Mecklenburg County
Health Department

Re: Gilead Road
File: 1631B
Parcel: 009-032-27PO

APPLICATION FOR IMPROVEMENT PERMIT FOR RESIDENTIAL SITE INDIVIDUAL WATER AND WASTEWATER SYSTEMS PROGRAM

SOIL/SITE EVALUATION for ON-SITE WASTEWATER SYSTEM

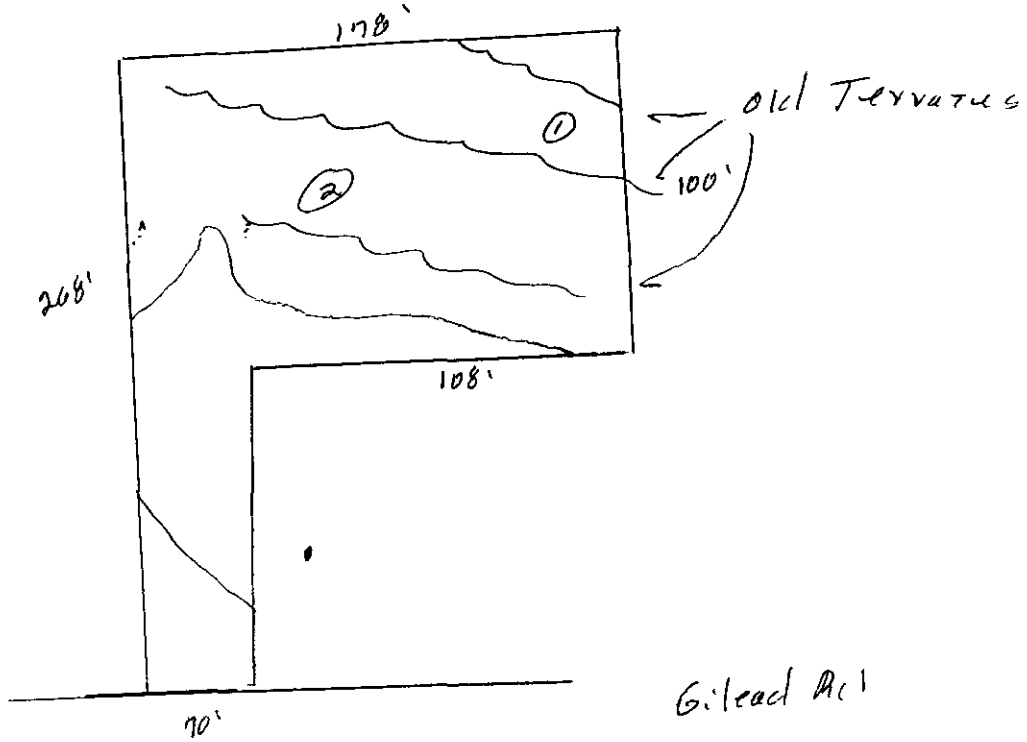
OTHER FACTORS (.1946):
SITE CLASSIFICATION (.1948): unsuitable
EVALUATED BY: M. A. Mabe 11-5-96

COMMENTS: 100% Repair
